Application by Beacon Fen Energy Park Ltd for an order granted development consent for the Beacon Fen Energy Park

Written Representation

**A report prepared by North Kesteven District Council
(ID F8D379496)**

Planning Inspectorate reference: EN010151

BMV Land 'Take'

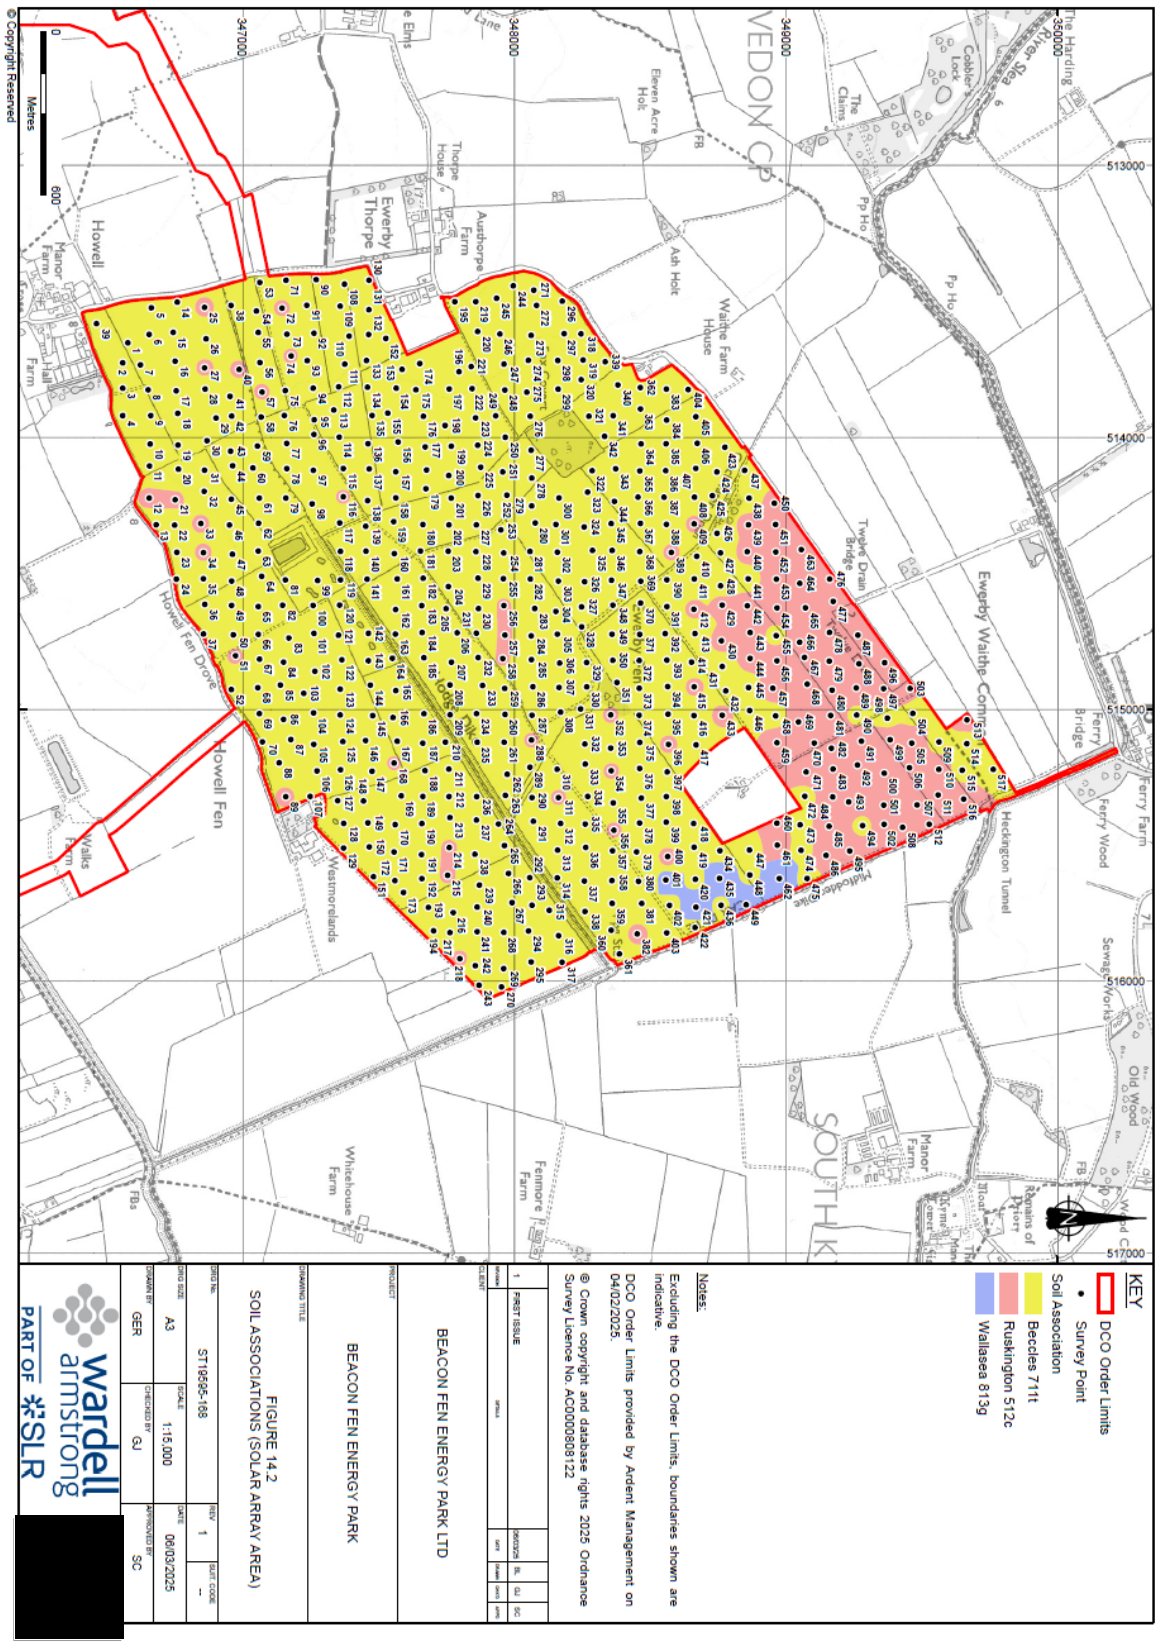
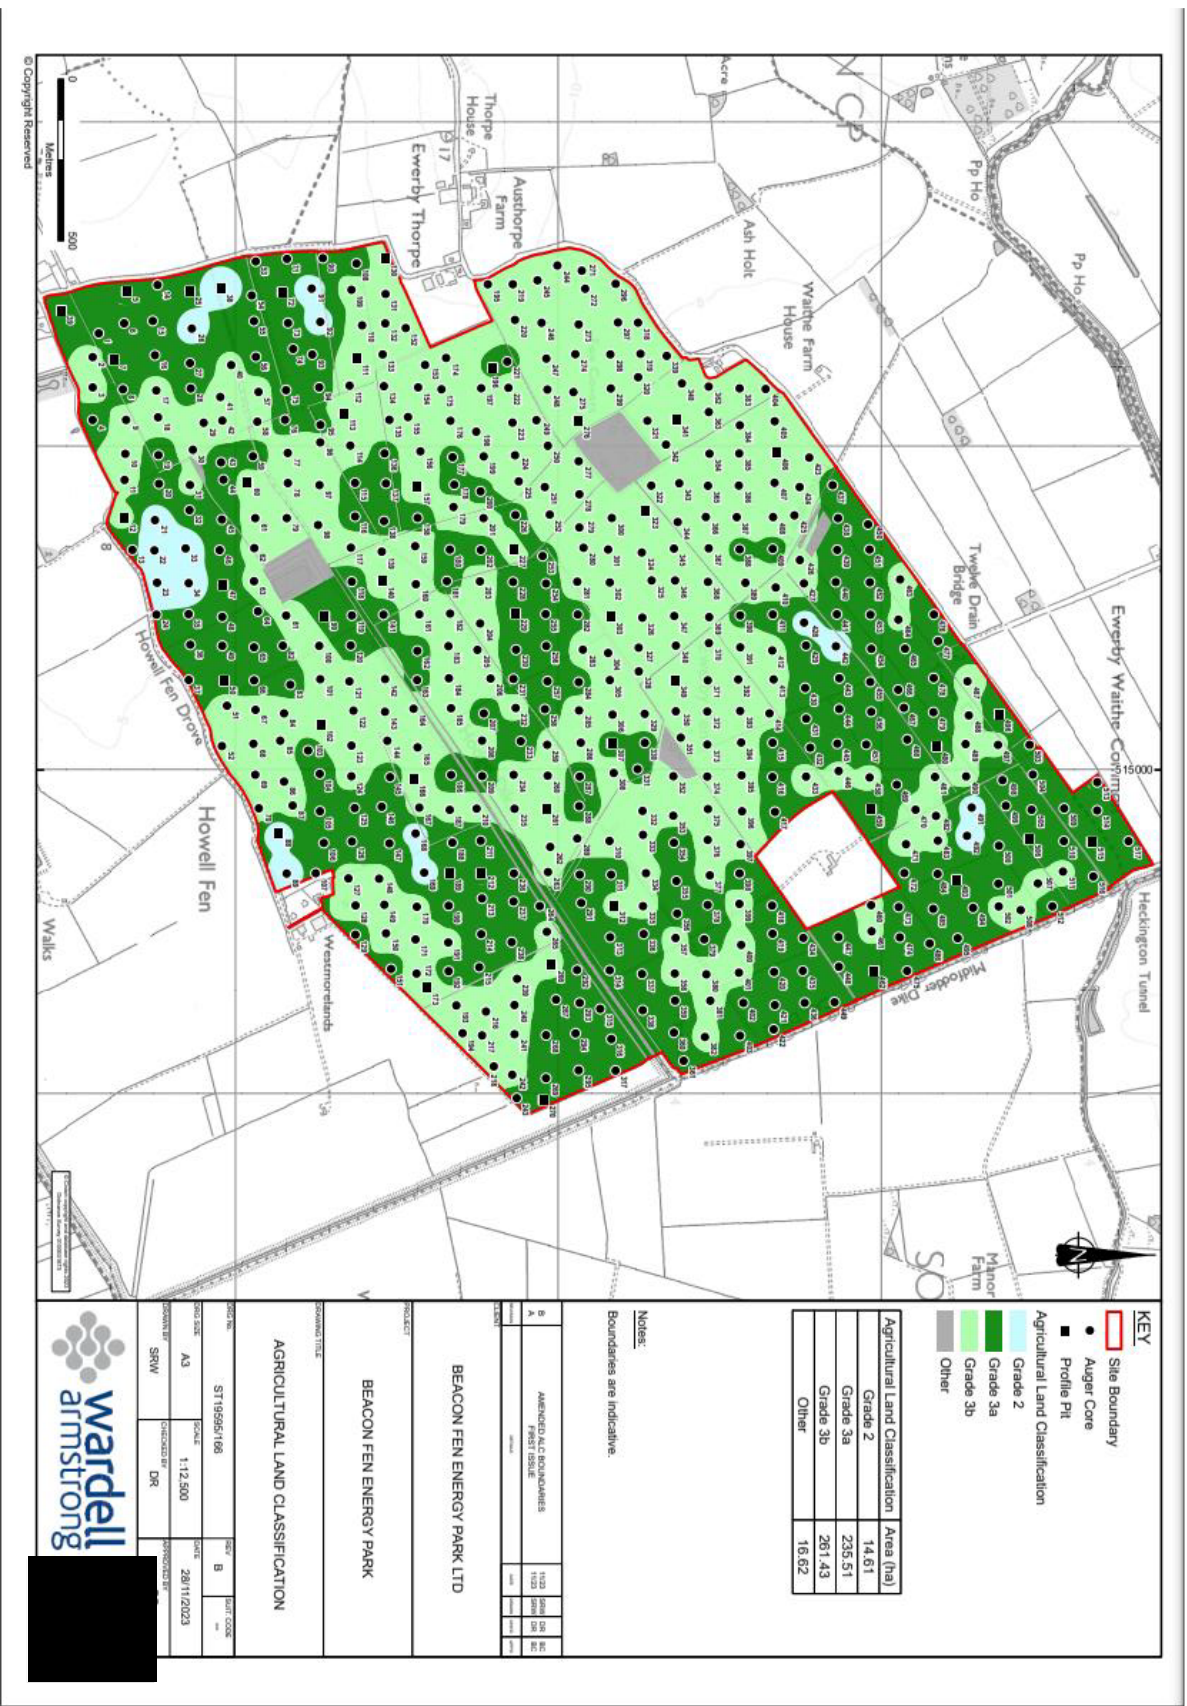
The overall ALC findings are found in tables in the ES chapter. Nearly 50% of the site is assessed as BMV. The total area of BMV land – mostly Grade 3a, and the remainder is non BMV being Grade 3b - moderate quality.

BMV land is considered as temporarily used under the panels, although 40 years is a long period. The amount of BMV land to be lost 'permanently' (mainly due to green infrastructure) is significant.

Nevertheless, the whole area is productive farmland, which will be removed from mainly arable farming for 40+ years and at best, a lower intensity grass based system will replace it. The loss of arable production is I consider locally significant and in view of other projects in the wider District and County potentially cumulatively significant.
